# HENDERSON COUNTY TECHINCAL REVIEW COMMITTEE

**SUBJECT:** Combined Master and Development Plan for Two Wheel Drive Major

Subdivision (2022-02-M)

#### **Henderson County Planning Department Staff Report**

#### 5. Total Project Proposal Summary:

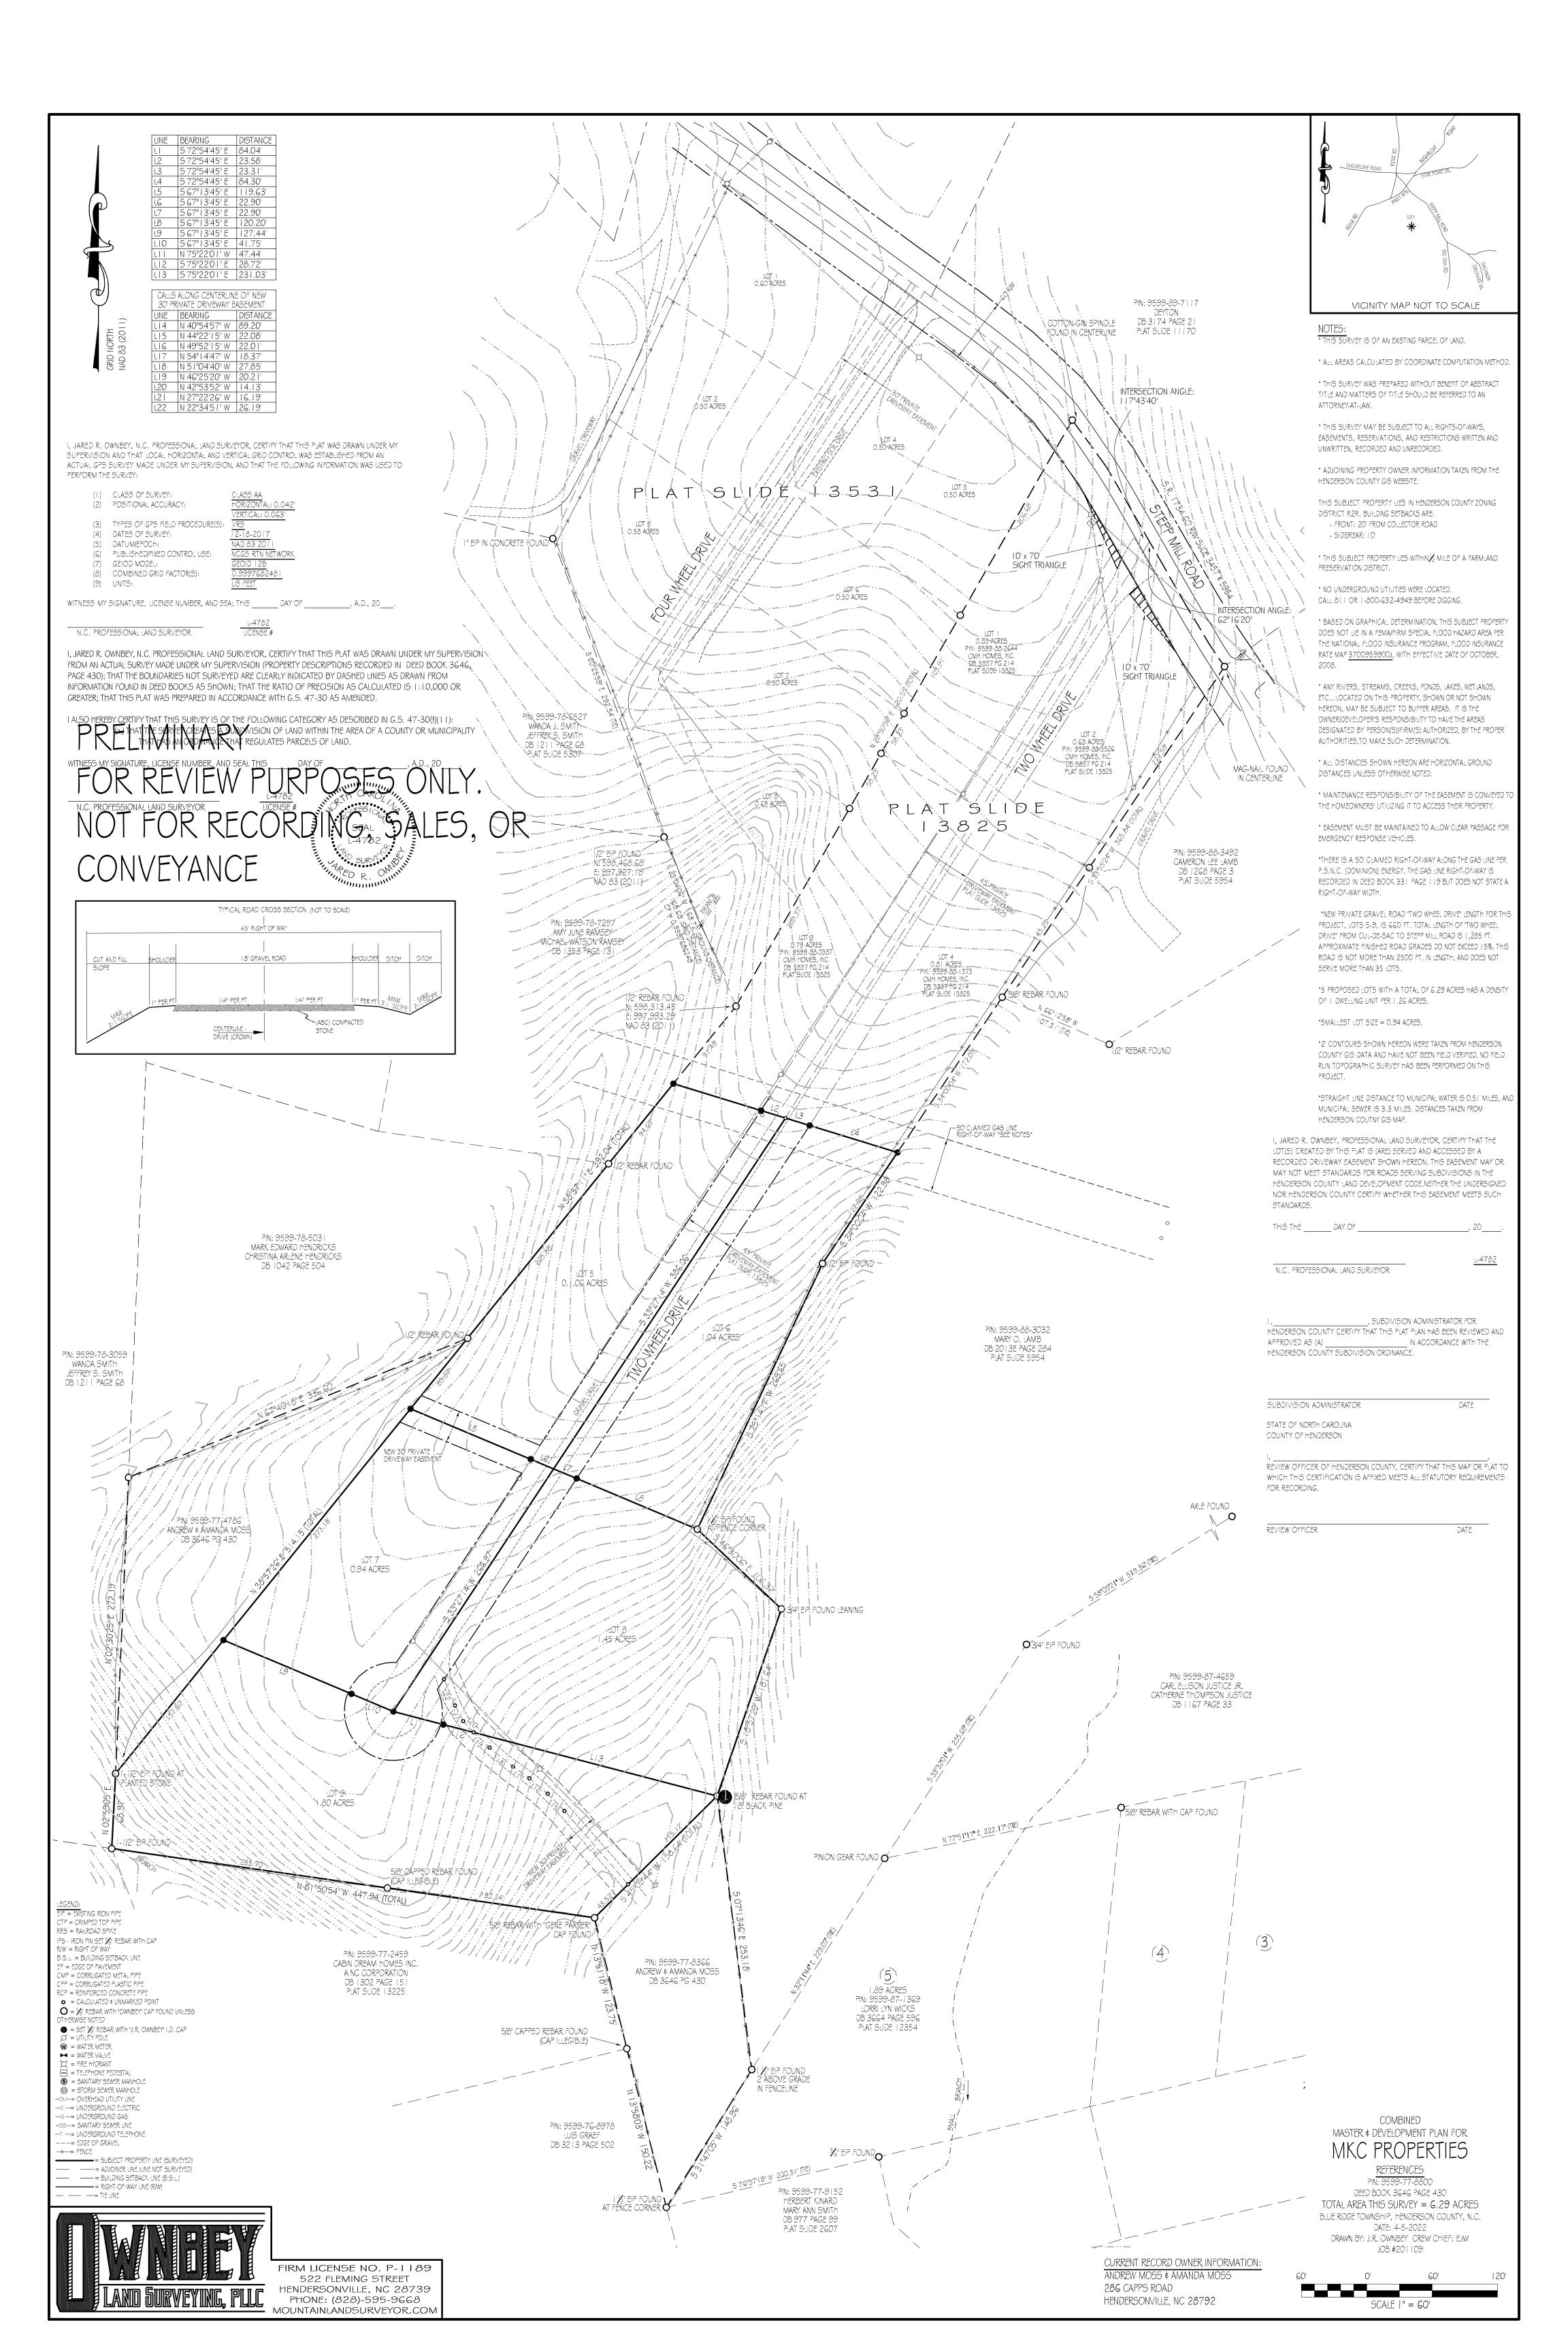
- 1. **Soil Erosion and Sedimentation Control Plan.** The Applicant shall submit written notice from the appropriate local agencies verifying that an Erosion and Sedimentation Control Plan has been received or a written notice from a professional land surveyor, engineer, landscape architect, architect, or professional planner certifying that no plan is required (LDC §42-95B).

- 2. **Water Quality.** The Applicant shall submit written notice from the appropriate local agencies verifying that a Stormwater Management Permit has been received (LDC §42-95E).

- 3. **Private Roads.** Private roads shall be constructed in accordance with the Private Subdivision Local Road standards stated in Chapter 42 (LDC§42-109).

- 4. **Shoulder Stabilization.** All areas disturbed by the construction of a public road, including cut and fill slopes, shoulders and ditch banks, shall be seeded to stabilize the soil and prevent erosion. Seeding should be done as soon as feasible after road construction (LDC §42-102).

- 5. **Road Drainage, Culverts and Shoulder Stabilization.** Road or drainage structures shall be constructed in accordance with state roads standards. Road drainage side ditches shall be constructed with sufficient depth and width to carry the expected volume of storm water runoff (LDC §42-100). All areas disturbed by the construction of a public road, including cut and fill slopes, shoulders and ditch banks, shall be seeded to stabilize the soil and prevent erosion. Seeding should be done as soon as feasible after road construction (LDC §42-105).

- 6. **Dead Ends, Cul-de-sacs and Turnarounds.** The Applicant proposes two (2) cul-de-sacs or turnarounds located at the ends of both local roads. All turnarounds must meet of the LDC §42-105 C(8).

- 7. **Road Name Signs and Regulatory Signs.** Road name signs and regulatory signs shall be provided in accordance with Chapter 142 of the Henderson County Code. Road name signs and regulatory signs must be acquired and installed prior to final plat approval (LDC §42-104).

- 10. **NCDOT Driveway Permit.** An NCDOT Driveway Permit is required for the proposed private, paved road, to access the site. Design should meet requirements of NCDOT.
